## Ground Water Review Form:

Application: T-13276

Applicant Name: Broken Spur Ranch LLC

T-13276, Broken Spur Ranch LLC

Well Location Map

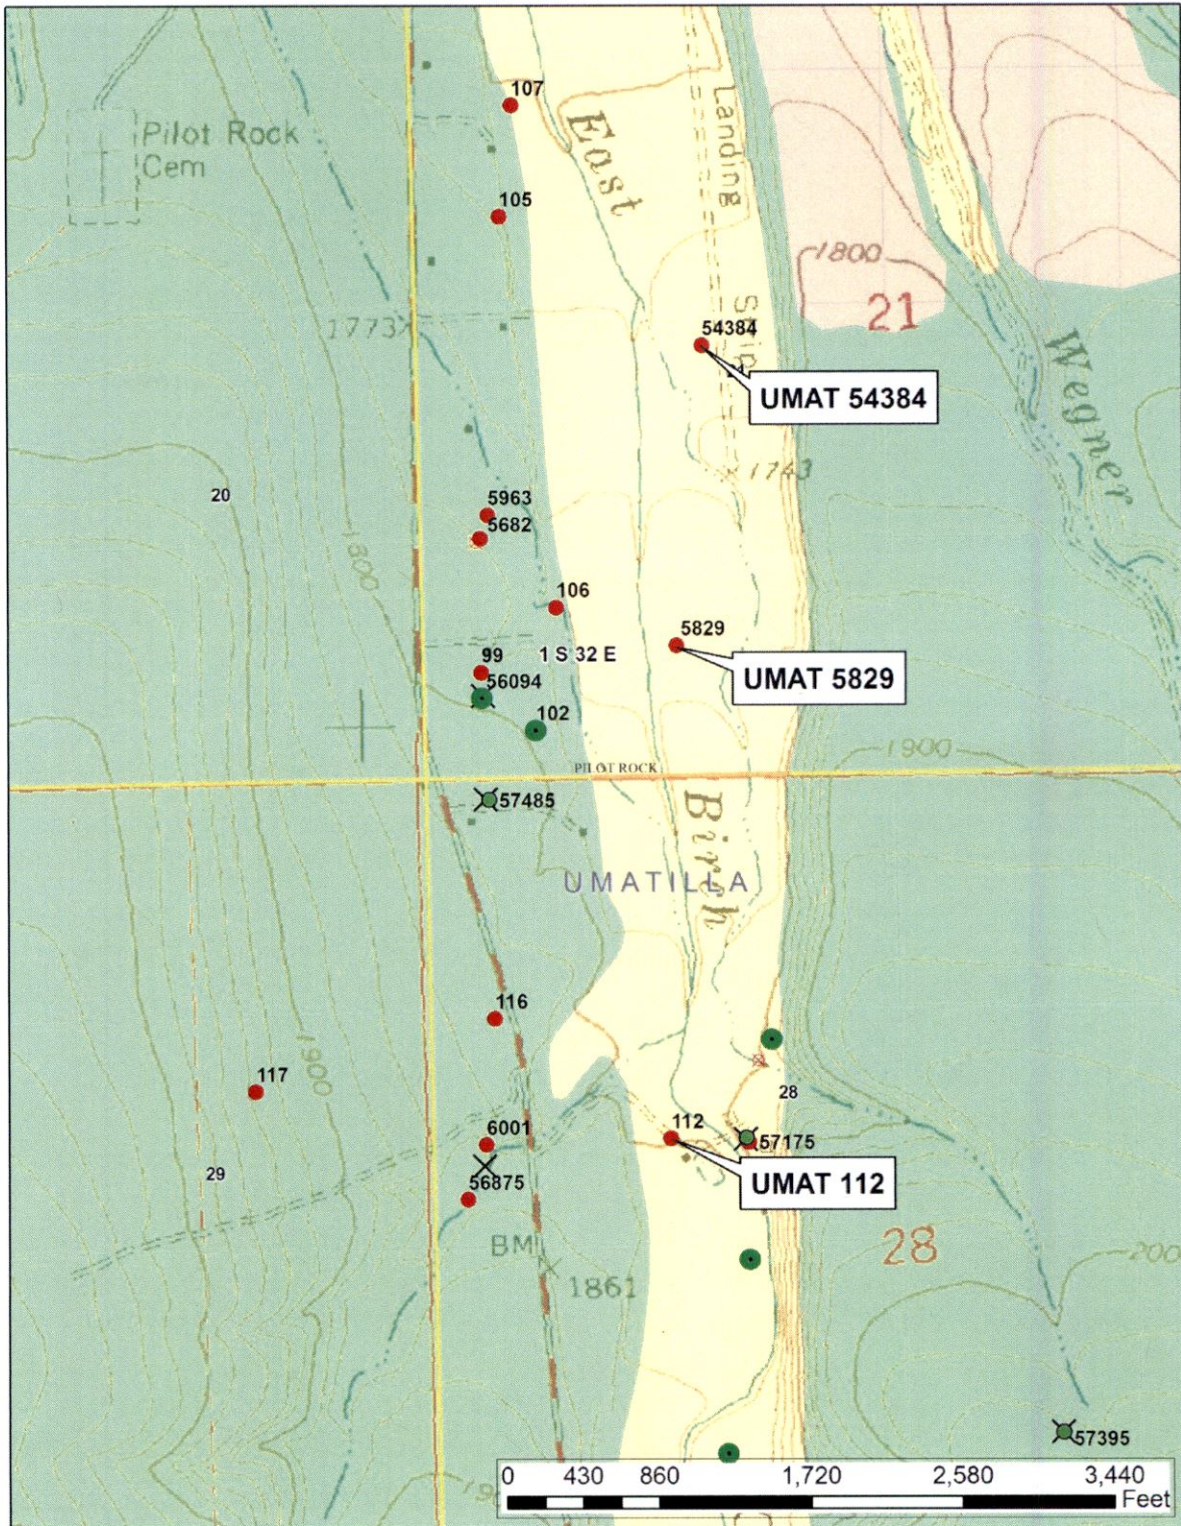
Yes  No Comments: All three POAs are located similar distances from Birch Creek, so interference should not increase.

**Theis Distance-Drawdown, Pumping Rate = 1.47 cfs**

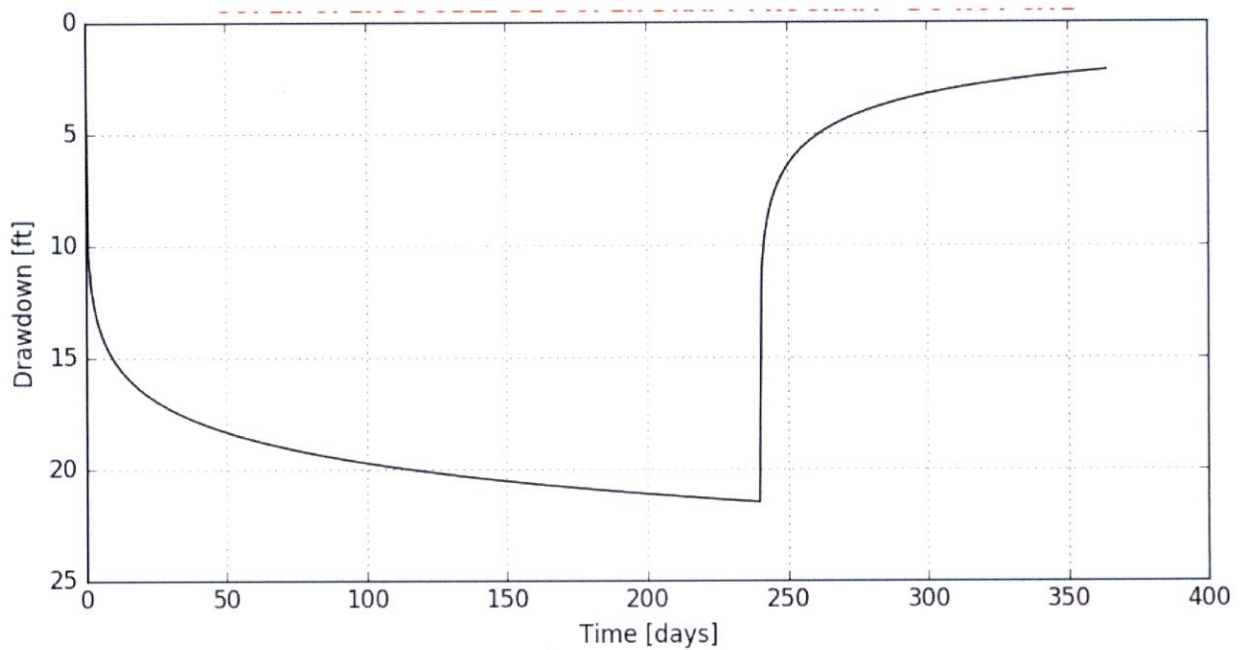
Yes  No Comments: If this application is approved, the maximum allowed rate at each of the POAs could increase to 1.47 cfs. The increase will be most significant if all production is from UMAT 5829 because the current certificated maximum pumping rate at this well is lowest (0.18 cfs). The increase in pumping rate will result in an increase in interference with nearby groundwater users.

Yes  No If yes, explain: Interference was assessed using the Theis Distance-Drawdown analytical model with parameters appropriate for Columbia River Basalt Group aquifers (see attached results). Two scenarios were evaluated to assess the increase in interference; 1) baseline interference with the nearest well (UMAT 106, Radial distance = 800 feet) was established using the maximum current pumping rate at UMAT 5829 (0.18 cfs), and 2) the increase in interference at UMAT 106 was estimated by assigning all potential pumpage associated with this application (1.47 cfs) to UMAT 5829. Estimated interference (drawdown) at UMAT 106 increases from 2.64 feet (current condition) to 21.57 feet (potential maximum). Modeling shows that maximum interference can increase by up to 19 feet, however, it is unlikely that any of the POAs can or will pump the maximum allowed rate. So, the actual increase in interference is expected to be much less.
